UPDATE TO OXFORDSHIRE COUNTY COUNCIL'S RESPONSE TO CONSULTATION ON THE FOLLOWING DEVELOPMENT PROPOSAL

Application No: 17/02534/OUT-3

Proposal: OUTLINE - The construction of a business park of up to 60,000 sq.m (GEA) of flexible Class B1(a) office / Class B1(b) research & development floorspace; parking for up to 2,000 cars; and associated highways, infrastructure and earthworks

Location: Land North Of Bicester Avenue, Garden Centre, Oxford Road, Bicester.

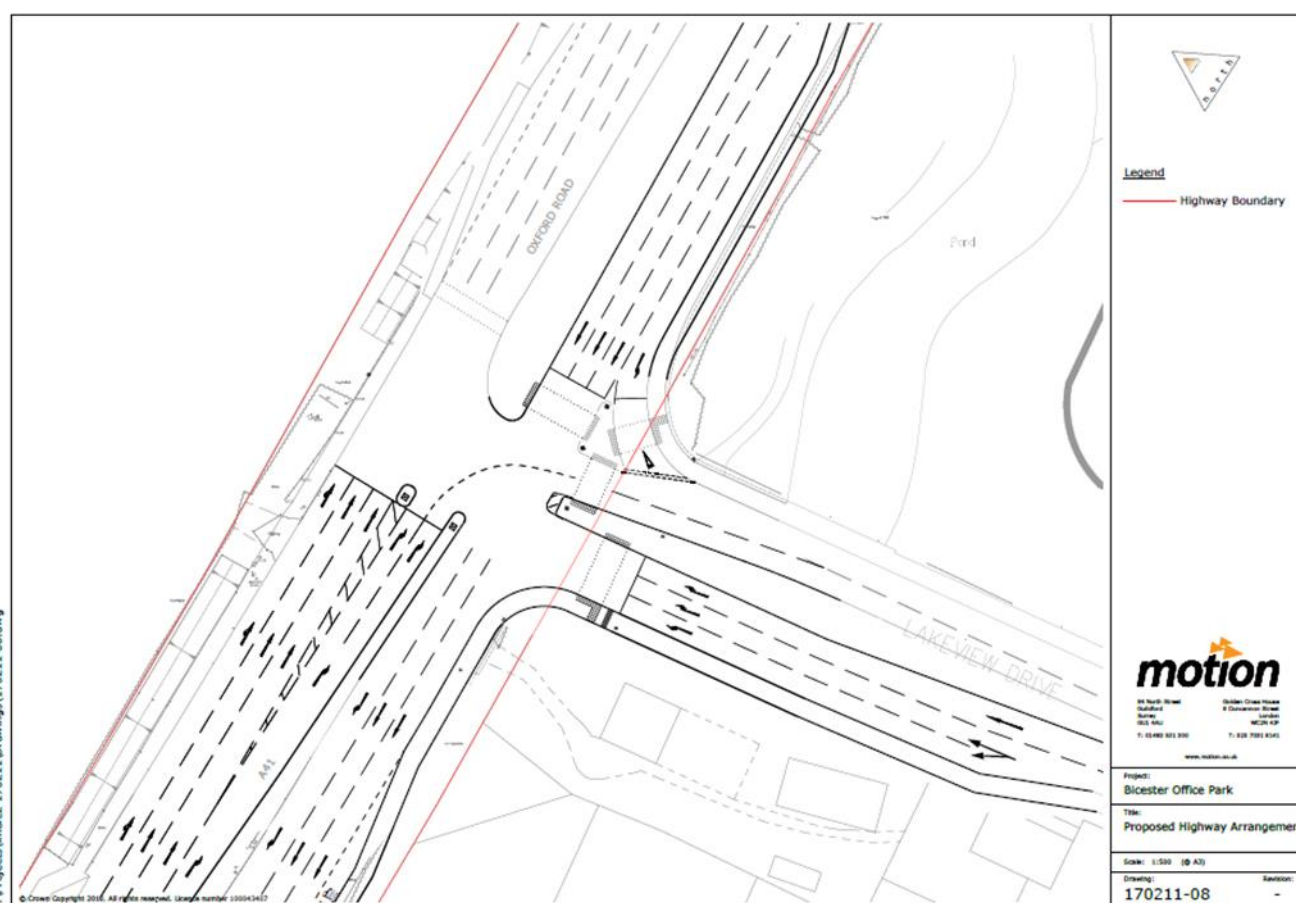
- Paragraph 8.9 states that third party advice has been sought on the appropriate threshold Degree of Saturation above which signalised junctions stop being considered to operate within capacity. It is the County Council's firm belief that in the transport industry it is widely accepted that where the Degree of Saturation (DoS) of a link in a LinSig model is shown to operate in excess of 90% DoS, that link is operating over capacity. The following extract from the TfL document "Traffic modelling Guidelines" supports this comment:

2.6.1.4 Junction Performance

It is useful to be aware of the relationship between traffic delay and DoS in order to best optimise junction performance during proposal development. The relationship illustrated within Figure 8 strengthens the considerations outlined in Part A, which highlight the role stable network performance can play in maintaining journey time reliability. Engineers should be mindful that delay begins to increase exponentially above approximately 85% DoS. At junctions operating close to zero Practical Reserve Capacity (PRC), corresponding to approximately 90% DoS, small reductions in capacity can result in a significant increase in delay. For this reason a DoS of 90% represents an upper limit of practical capacity for signalised junctions. Unsignalised junctions typically have a lower practical capacity limit, with DoS in the range 80-85%. Junction capacity relationships are important when designing schemes in order to ensure that new proposals perform capably within the existing network.

Notwithstanding this, the LinSig modelling results for queuing show that the mitigation scheme is not adequate in terms of the resultant queueing. In other words, OCC is not objecting on the basis of an obscure technicality, but on predicted queueing, as paragraph 8.10 goes on to explain.
